GRACE PARK

AN ADDITION TO WICHITA, SEDGWICK COUNTY, KANSAS

RE: SUB 2002-132 -- Final Plat of Grace Park Addition

CASE NUMBER: SUB 2002-132 -- GRACE PARK ADDITION

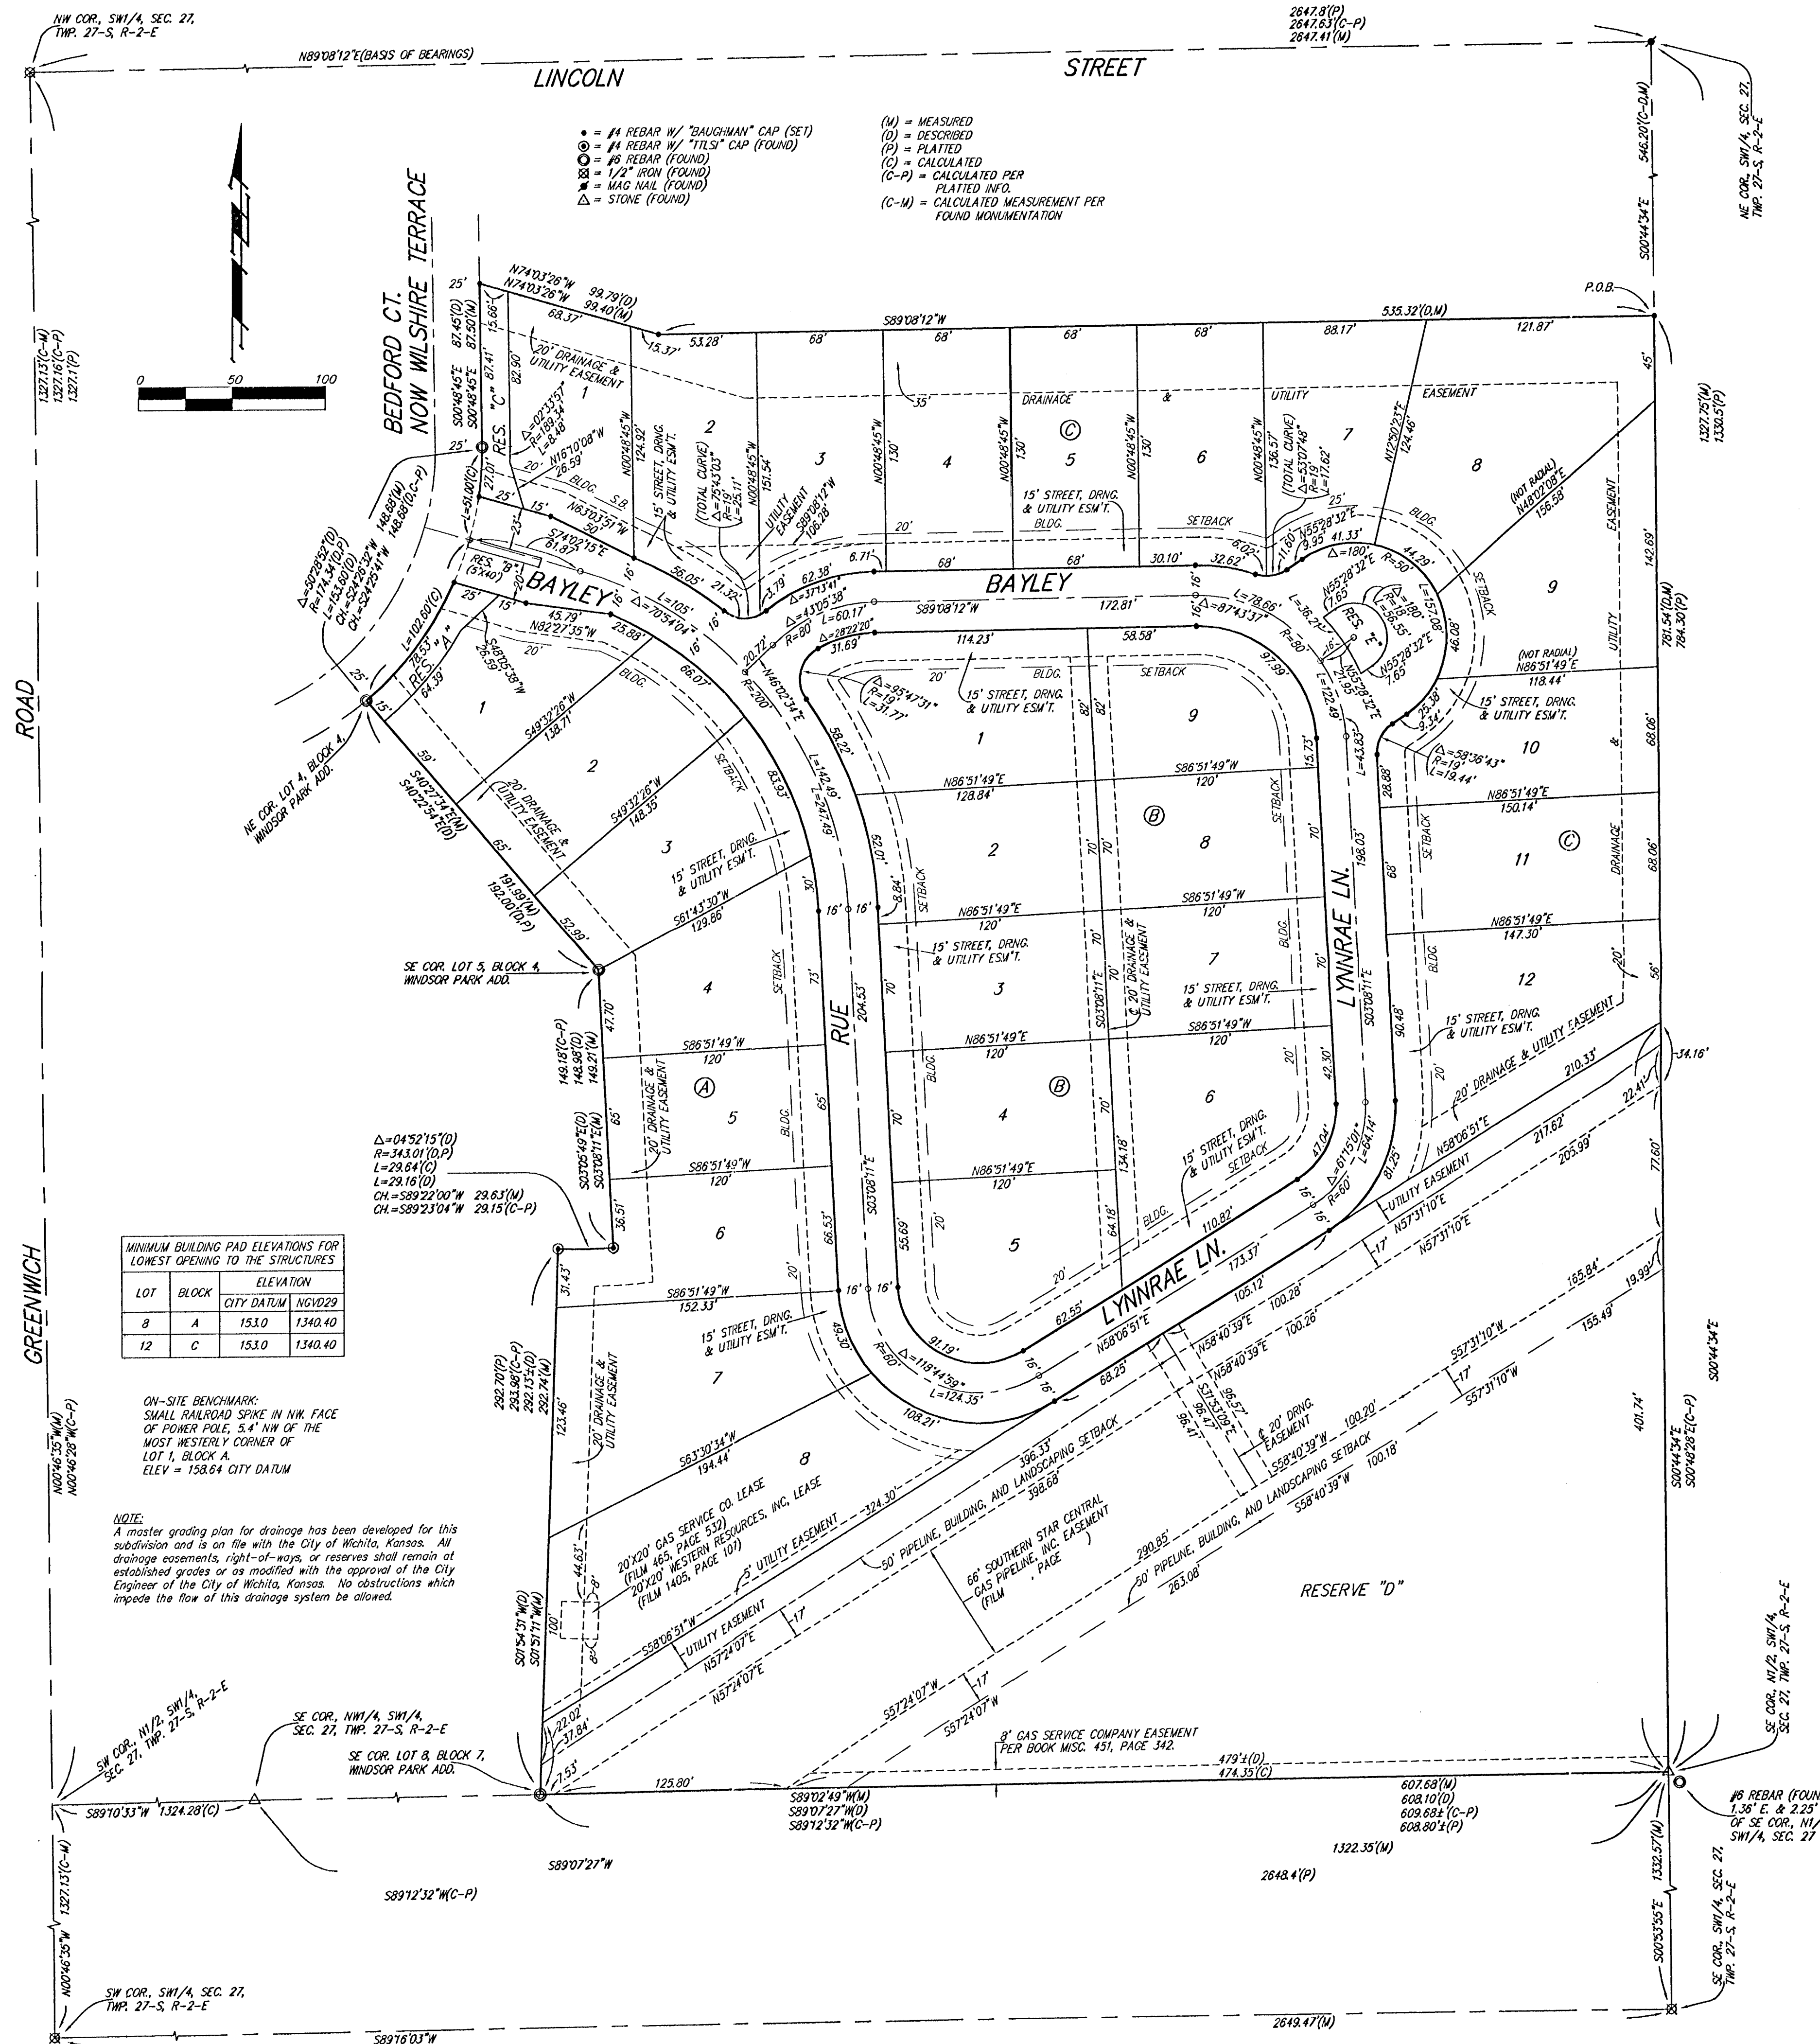
- A. The applicant shall guarantee the extension of sanitary sewer and City water to serve the lots being platted.
- B. If improvements are guaranteed by petition, a notarized certificate listing the petitions shall be submitted to the Planning Department for recording.

- C. An off-site right-of-way dedication shall be submitted connecting Bedford to Lincoln.
- D. City Engineering has approved the drainage plan.
- E. Direct access from this site through Windsor Park to the west will be eliminated through the following: 1) the applicant shall construct a hammerhead turnaround for Bedford Ct south of the entrance to the site, 2) the applicant shall construct a circular turnaround for Bedford Ct just south of Lincoln.

- F. City Fire Department has requested an emergency access easement from one of the turnarounds. Standard gating and signing are required per City Fire Department standards.

- G. The applicant shall guarantee paving improvements of the off-site right-of-way from Lincoln extending along Bedford Ct to the entrance of the subdivision in accordance with City Engineering. The applicant shall also guarantee the paving of the proposed interior streets. For the narrow public 32-foot streets, this guarantee shall be for the 29-foot paving standard. The applicant has also agreed to construct a sidewalk along the east side of Bedford Ct from the entrance of the subdivision extending north to Lincoln.

- H. Since this plat proposes the platting of narrow street right-of-way with adjacent "15-foot street drainage and utility easements", a restrictive covenant shall be submitted which calls out restrictions for lot-owner use of these easements. Retaining walls and change of grade shall be prohibited within these easements as well as fences, earth berms and mass plantings.

- I. The applicant shall submit a covenant which provides for four (4) off-street parking spaces per dwelling unit on each lot which abuts a 32-foot street. The covenant shall inventory the affected lots by lot and block number and shall state that the covenant runs with the land and is binding on future owners and assigns.

- J. The Blocks shall be relabeled as A and B.
- K. 20'x20' gas lease area needs located on plat.
- L. Approval of this plat will require a waiver of the lot depth to width ratio of the Subdivision Regulations for Lot 8, Block A. The Subdivision Regulations state that the maximum depth of all residential lots shall not exceed 2.5 times the width. The Subdivision Committee has approved the modification.

- M. GIS has requested that Bedford Ct be revised to Wilshire Ter.
- N. The platting binder indicates a party holding a mortgage on the site. This party's name must be included as a signatory on the plat, or else documentation provided indicating that such mortgage has been released.

- O. The applicant shall submit a copy of the instrument which establishes the pipeline easements on the property, which verifies that the easements shown are sufficient and that utilities may be located adjacent to and within the easements. Any relocation, lowering or encasement of the pipeline, required by this development, will not be at the expense of the City.

- P. The applicant's agent shall determine any setback requirements for the pipelines by researching the text of the pipeline agreements. If a setback from the pipeline easements is provided for in the pipeline easement agreements, it shall be indicated on the face of the plat.

- Q. For any lots with existing tree rows that may be impacted by the installation of utilities, it is recommended that 30-ft utility easements be platted in order to allow for the installation of the utilities without damage to such tree rows.

- R. The platting text shall include language that a drainage plan has been developed for the plat and that all drainage easements, rights-of-way, or reserves shall remain at established grades or as modified with the approval of the applicable City or County Engineer, and unobstructed to allow for the conveyance of stormwater.
